UNITED STATES PATENT AND TRADEMARK OFFICE

APPLICATION NO.	FILING DATE	FIRST NAMED INVENTOR	ATTORNEY DOCKET NO.	CONFIRMATION NO.
10/595,283	04/10/2006	Bocang QIU	305832-00124	6702
64770 7590 09/04/2007 MOMKUS MCCLUSKEY MONROE MARSH & SPYRATOS, LLC 3051 OAK GROVE ROAD SUITE 220 DOWNERS GROVE, IL 60515-1181			EXAMINER ROJAS, OMAR R	
			ART UNIT 2874	PAPER NUMBER
			MAIL DATE 09/04/2007	DELIVERY MODE PAPER

Office Action Summary

DETAILED ACTION

FIG. 1

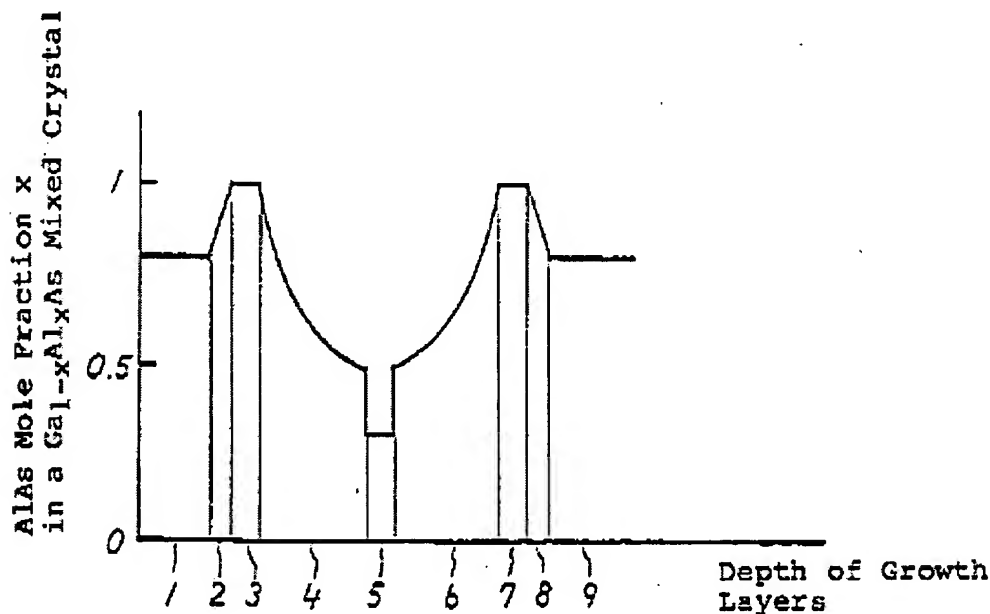
In re claim 1, Hayakawa discloses a semiconductor optical waveguiding device comprising:

a first cladding layer 1/2/3/4;

a second cladding layer 6/7/8/9; and

a waveguiding layer 5 disposed between the first and second cladding layers and having a substantially higher refractive index than said first and second cladding layers;

wherein at least one of the first and second cladding layers includes a beam control layer 2/4/6/8 in which a property of the semiconductor material varies as a function of depth through the layer, the beam control layer including a first sub-layer 2/8 in which the property varies gradually from a first level to a second level, and a second sub-layer 4/6 in which the property varies gradually from said second level to a third level. Figure 1 of Hayakawa is reproduced below.

FIG. 7

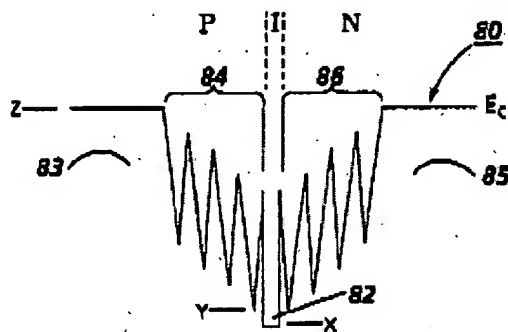
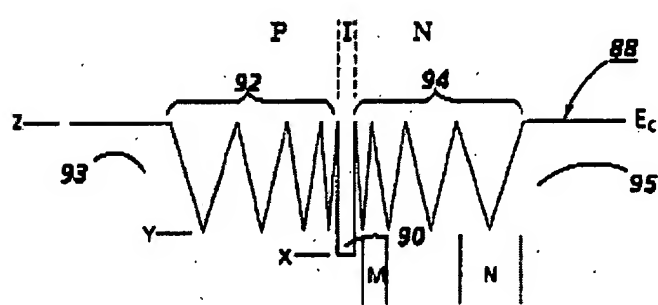
In re claim 1, Scifres discloses a semiconductor optical waveguiding device 80/88 comprising:

a first cladding layer 85/86 or 94/95 ;

a second cladding layer 83/84 or 92/93; and

a waveguiding layer 82 or 90 disposed between the first and second cladding layers and having a substantially higher refractive index than said first and second cladding layers;

wherein at least one of the first and second cladding layers includes a beam control layer 84/86 or 92/94 in which a property of the semiconductor material varies as a function of depth through the layer, the beam control layer including a first sub-layer in which the property varies gradually from a first level to a second level, and a second sub-layer in which the property varies gradually from said second level to a third level. Figures 7 and 8 of Scifres are reproduced below.
